RE: Preliminary Plan No. 120240110
Sketch Plan No. 32019006B
PLD Lot 44 - 4702 West Virginia Avenue

We have completed our review of the preliminary and sketch plans uploaded to eplans on July 23, 2024. Previous versions of these plans were reviewed by the Development Review Committee (DRC) at its meeting on May 21, 2024. We recommend approval of the plans subject to the following comments:

820240140 PLD Lot 44 & 4702 West Virginia Ave

Re: **REVISED COMBINED STORMWATER
MANAGEMENT CONCEPT/SITE
DEVELOPMENT STORMWATER
MANAGEMENT PLAN** for
West Chevy Chase Heights
Preliminary Plan #: 820200100
SM File #: 285629
Tract Size/Zone: 0.60 ac. / CRT-0.5
Total Concept Area: 0.59 ac.
Lots/Block: Lots 11-14, 29 / Block 9
Parcel(s): N/A
Watershed: Lower Rock Creek
Redevelopment (Yes/No): Yes

**FIRE APPARATUS
ACCESS PLAN
820240140**

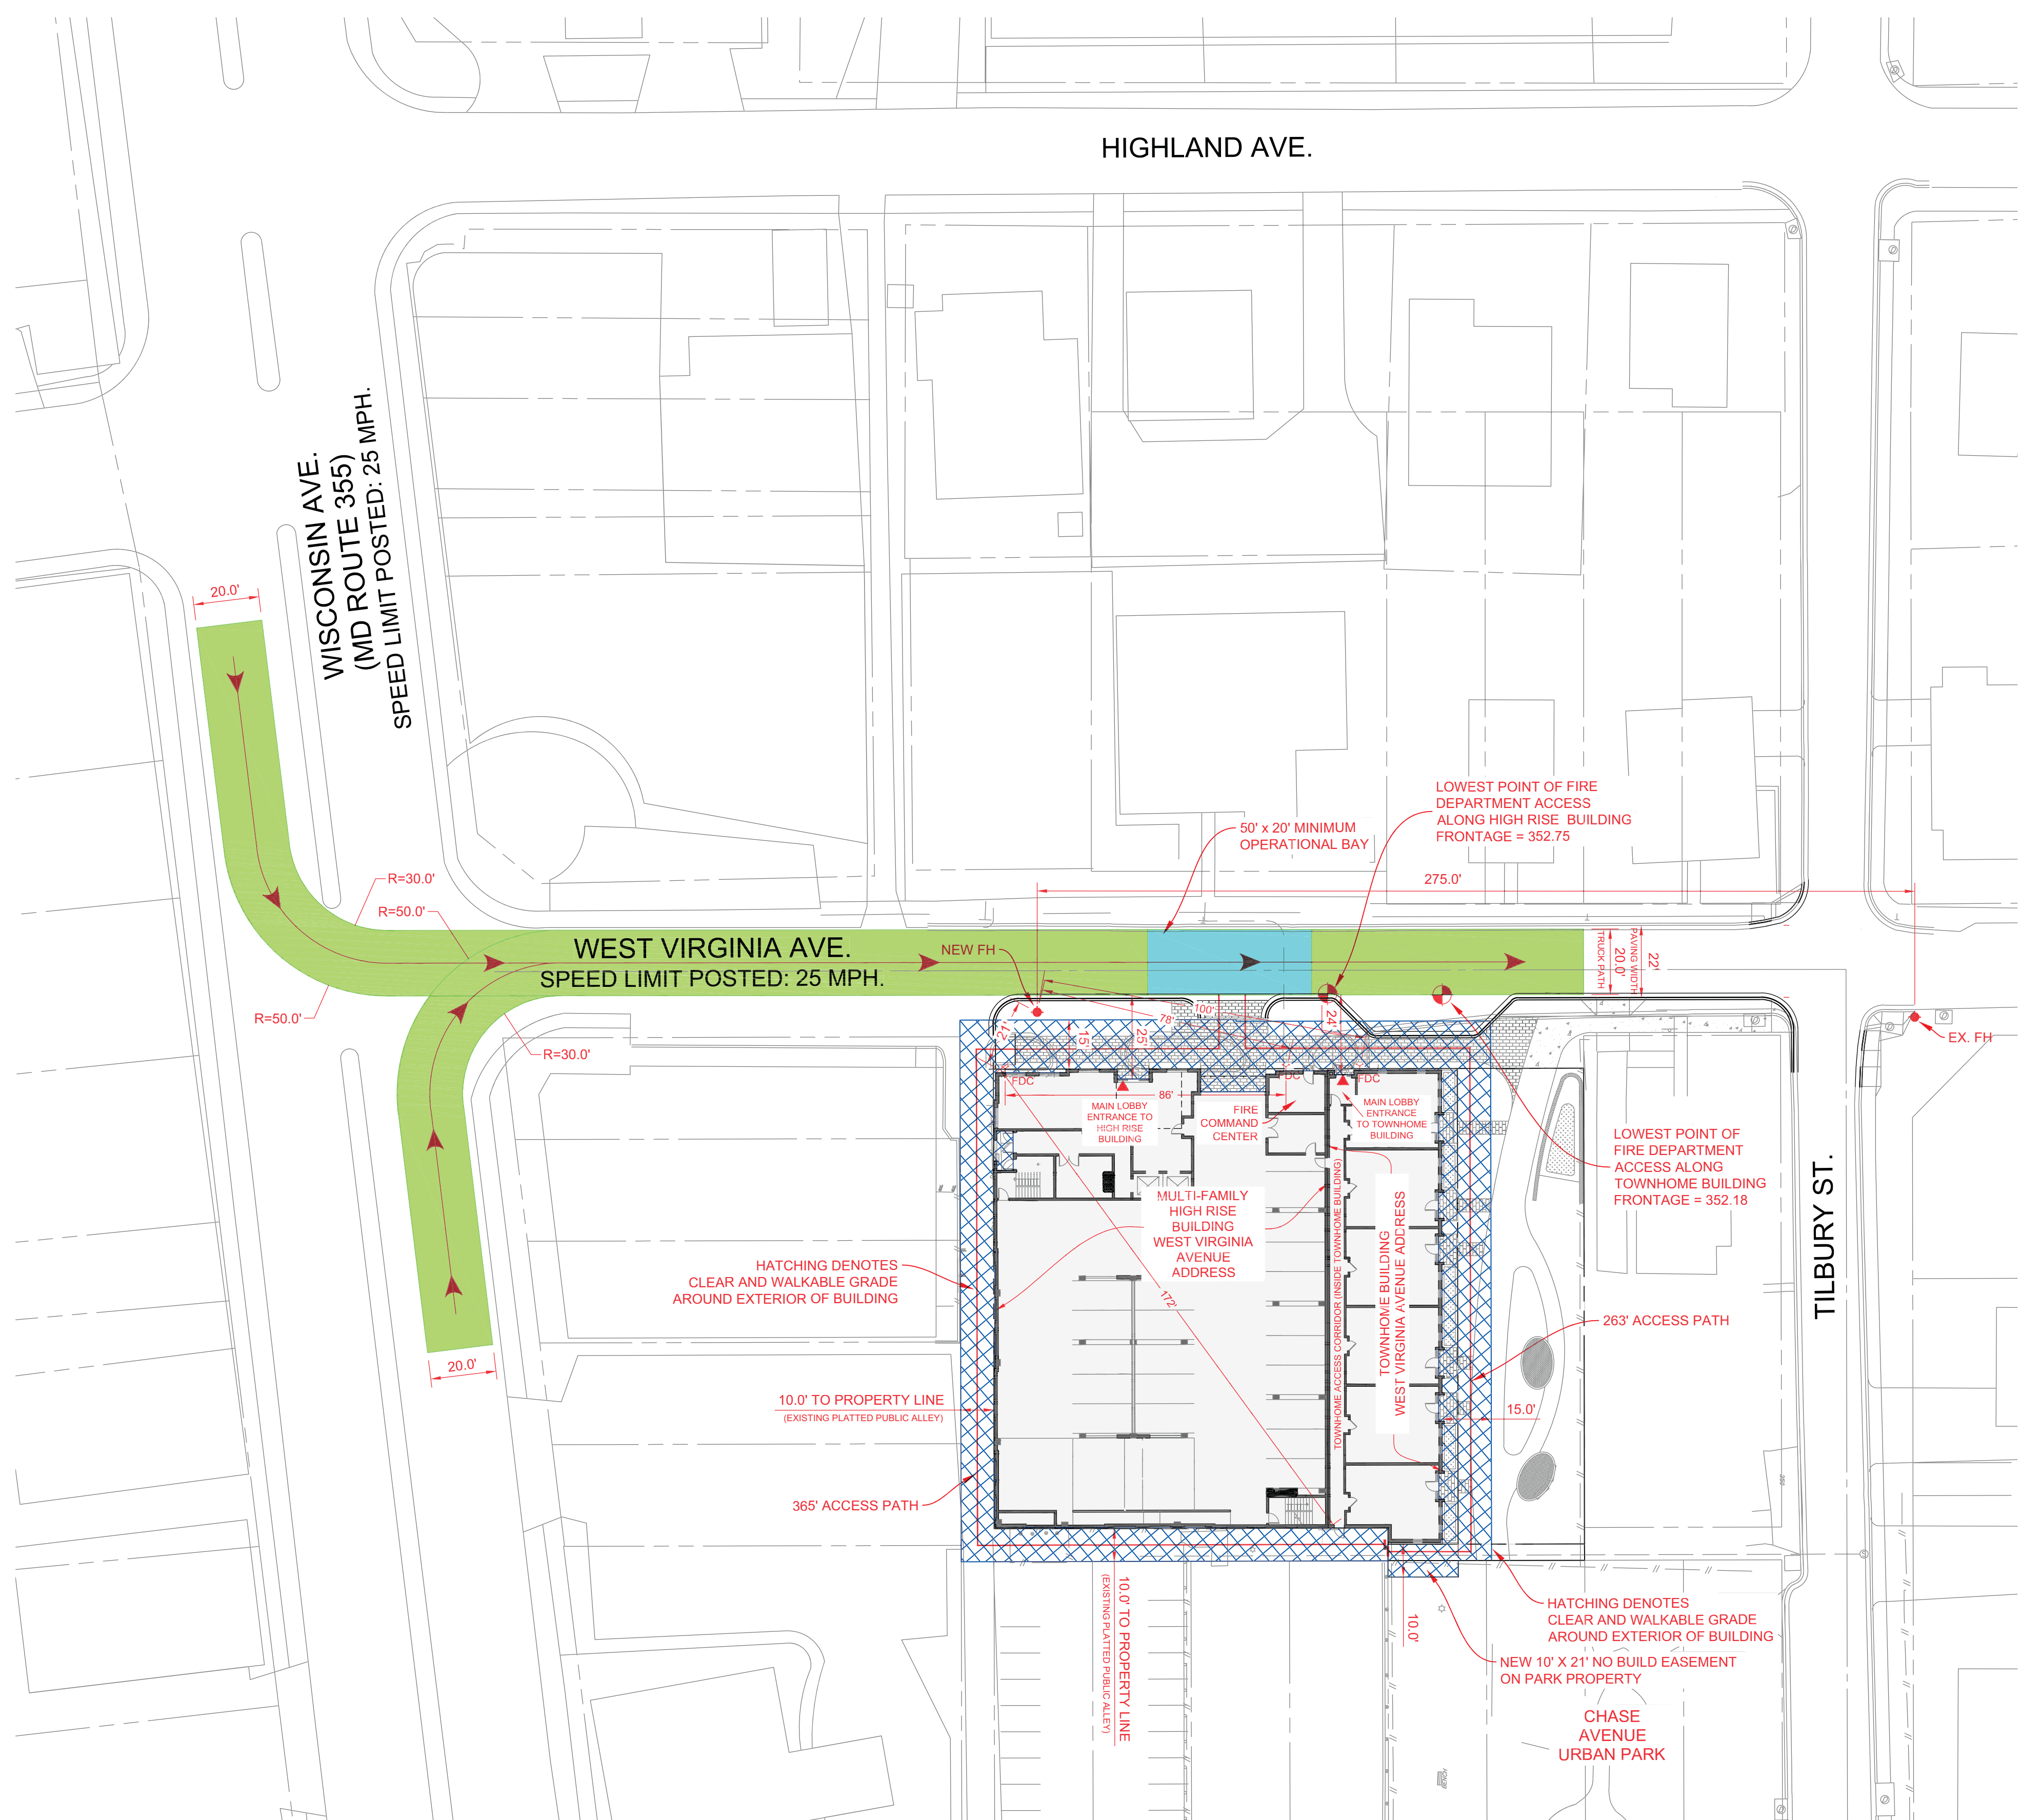
On behalf of the applicant, BB 4702 Holdings LLC we hereby request approval of a Performance Based Design in accordance with Executive Regulation 8-16 Section 22.00.07.81 as an alternative to the access requirements in NFPA 1, Section 18.2.3.2.3.6. The project consists of two buildings that will sit on top of a single parking garage. The western building is a multi-family high rise structure. The eastern building is a low rise townhome style multi-family building. Due to the limited size of the property, 15 feet of clear and unobstructed walkable grade cannot be provided on the west and south sides of the building. A reduction to 10 feet is requested along these two frontages. An existing 10' platted public alley provides 10' along the entire western frontage and most of the southern frontage. To accommodate the last 21' of structure on the southeast side, a new 10' "no build" easement will be granted by the Montgomery Parks Department. The easement will be granted and recorded prior to Use & Occupancy Certificate issuance for either of the new buildings.

For your use in reviewing this request, we have included a Fire Access Plan with the building's first floor plan overlaid.

PLAN APPROVED

1. Review based only upon information contained on the plan submitted **02-Jul-24** .Review and approval does not cover unsatisfactory installation resulting from errors, omissions, or failure to clearly indicate conditions on this plan.
2. Correction of unsatisfactory installation will be required upon inspection and service of notice of violation to a party responsible for the property.

Review based only upon information contained on this plan. Does not cover unsatisfactory layout resulting from omissions, errors or failure to clearly indicate conditions on this plan. Correction of such unsatisfactory layout to afford required access will be required if found upon inspection after installation
